# DA Form 1 – Development application details

Applicant name(s) (individual or company full name)	John Donald
Contact name (only applicable for companies)	Jarrold Williams
Postal address (P.O. Box or street address)	51 Sheridan Street
Suburb	Cairns
State	QLD
Postcode	4870
Country	Australia
Contact number	07 4281 6897
Email address (non-mandatory)	jarrod@aroindustries.com.au
Mobile number (non-mandatory)	N/A
Fax number (non-mandatory)	N/A
Applicant's reference number(s) (if applicable)	ARO0188 – Lot 3 Port Douglas Road

### DOCUMENT CONTROL SHEET

**TYPICAL BIN HARDSTAND**  
SCALE 1:50

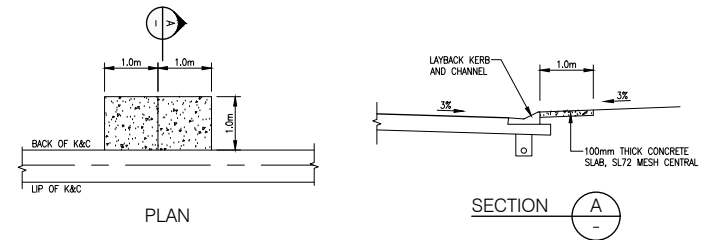
<p>An amended plan incorporating the above requirements must be submitted prior to the issue of a Development Permit for Operational Works.</p> <p>All works must be carried out in accordance with the approved plans, to the requirements and satisfaction of the Chief Executive Officer prior to the issue of a Compliance Certificate for the Plan of Survey.</p>	
4	<p><b>Crossover and Driveway to Lot 4 on RP729037</b></p> <p>The access crossover and driveway to the neighbouring Lot 4 on RP729037 (as proposed on the Approved Plans) must be constructed in accordance with FNQROC Development Manual Standard Drawings S1015/1105 and S1110 to a Residential standard.</p> <p>The driveway must be provided with a reinforced concrete driveway and must have a minimum width of 3.0m, extending the full length of the access leg to the allotment. It is to be splayed on the entry/exit and corner of Lot 4 on RP729037 to provide sufficient space for access for a articulated vehicle.</p> <p>The constructed driveway must commence at the adjacent kerb and channel with a standard kerb crossover or at the existing edge of pavement.</p> <p>Conduits for internal allotment services must be provided adjacent to the concrete driveway with the correct clearances for the full length of the driveway, unless otherwise approved.</p> <p>Additionally, the applicant shall provide a concrete bin set down adjacent the kerb on the western side of the proposed driveway access for Lot 4 on RP729037. The concrete bin set down must accommodate two wheelie bins and remain a minimum of 1m clear from the driveway.</p>	<p>A 3.5m wide commercial crossover is provided for entry to the neighbouring Lot 4 and is splayed at both exit and entry for Heavy Rigid Vehicle access, allowing for service vehicle access such as Councils refuse collection vehicles. The access intersection to the proposed road does not accommodate an Articulated Vehicle and therefore providing this level of service for the crossover would provide no additional access for this lot.</p> <p>The proposed crossover complies and starts at the adjacent kerb and channel with a standard kerb crossover</p> <p>Provision for services conduits has been made in the design and will be provided as part of construction.</p> <p>The proposed design provides a concrete bin hard stand. Refer to ARO0188-C15 for details.</p>

TO 1000mm HIGH  
TYPE 2 WALL DETAIL  
NOT TO SCALE

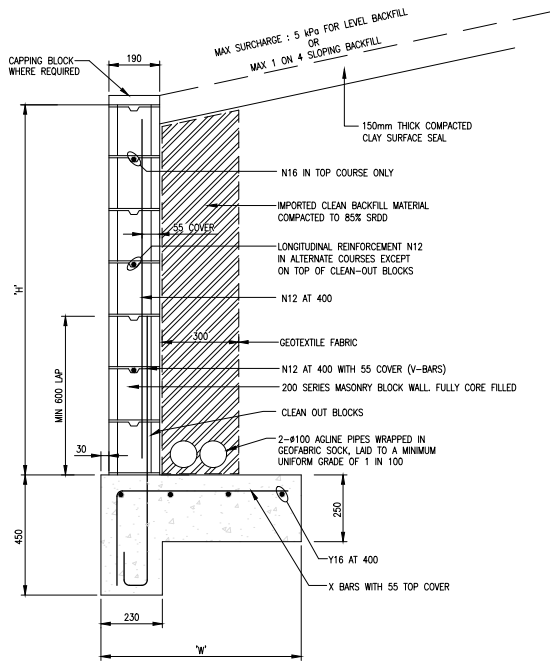
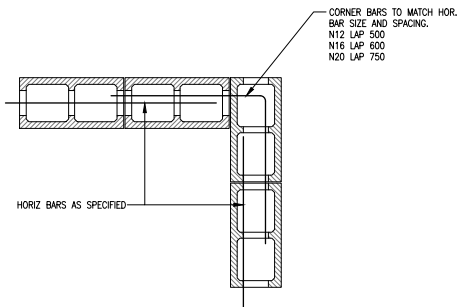
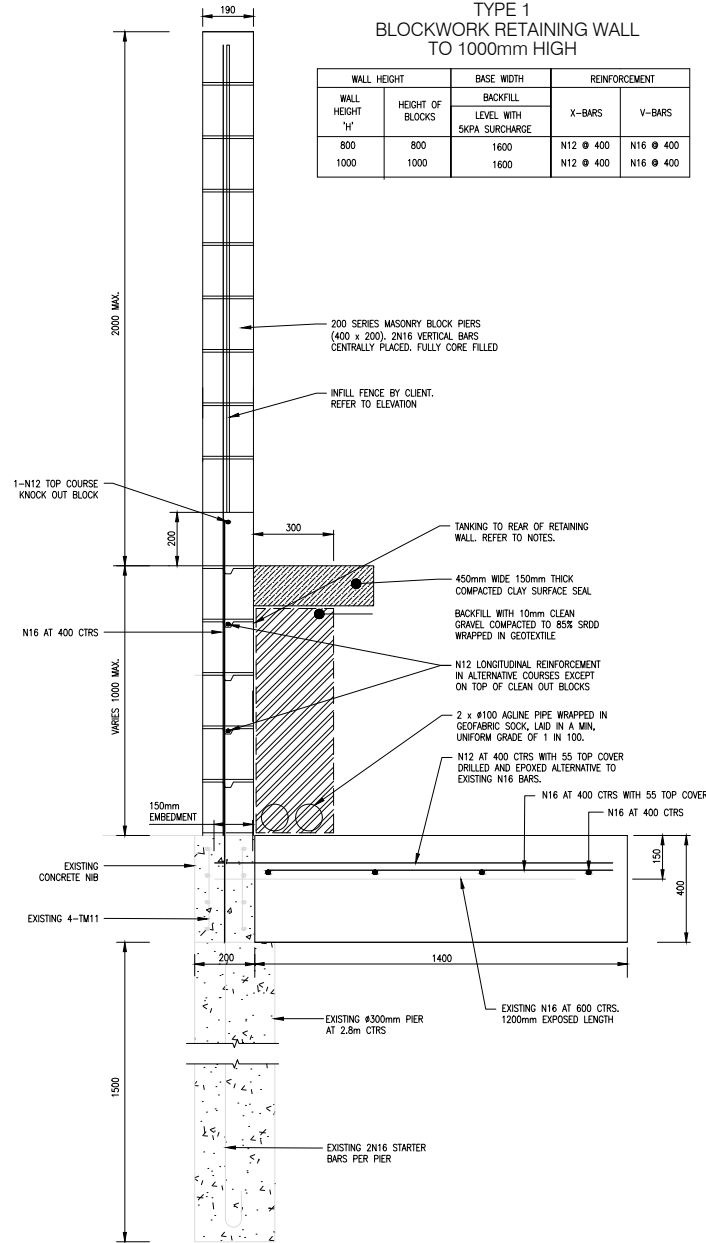
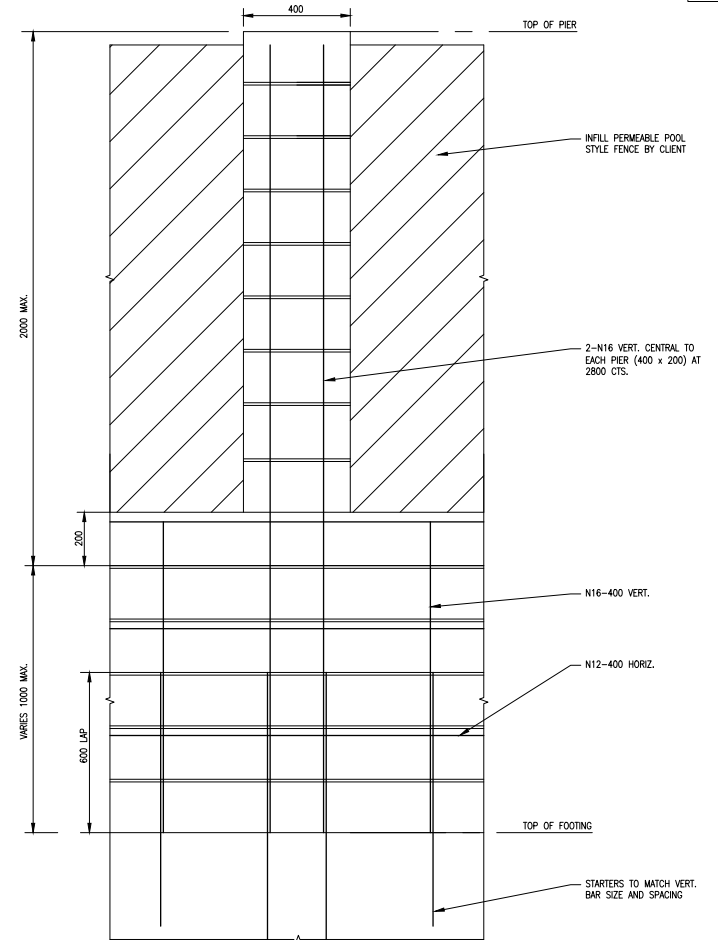
No.	General Requirements	Response and Supporting Information
7	<p><b>Retaining Walls and Structures</b></p> <p>a. The height of the proposed retaining wall at the rear of lots 6 to 9 is to be increased to avoid the earthworks fill batter discharging runoff to the existing lot.</p> <p>b. the applicant needs to demonstrate the proposed batter along the southern boundary of Lots 1 to 4 (bordering Lot 4 RP 729037), and the eastern boundary of lot 4 that borders Lot 5 of the proposed development, is sufficient with appropriate drainage so as not to cause upstream, downstream or surrounding impacts to the neighbouring lots. Consideration can be given to replacing the batters with a retaining wall with runoff directed to the new road.</p> <p>Retaining walls must include adequate drainage behind the top of the wall to ensure surface stormwater flows do not flow over the top of the wall but are contained in a designed system to pass the wall and include appropriate scour protection to the base of the wall.</p> <p>All retaining walls or structures higher than 1 metre must be structurally certified. Where the profile or height of the wall is redesigned during structural certification, amended plan(s) must be approved by Council.</p> <p>These details must be provided on the engineering plans prior to Council approval of the operational works.</p>	<p>a. All lots fall to the internal road. Refer to ARO0188-C13 and C14 for details.</p> <p>b. The majority of lots 1-4 fall to the internal road with a small batter existing for a portion of this boundary. The stormwater discharging from this area to Lot 4 does not exceed the pre development amount. Refer to the provided stormwater management plan for details. There is a retaining wall located at the eastern boundary of lot 4.</p> <p>Retaining walls have 2 x 100mm dia agline pipe wrapped on geofabric sock, laid in a min, uniform grade of 1 in 100. Refer to ARO0188-C25 for details.</p> <p>IFC Retaining walls drawings will be structurally certified, maximum proposed wall height is 1m. Refer ARO0188-C13 for earthworks and retaining wall layout plan and ARO0188-C25 for retaining wall details.</p>
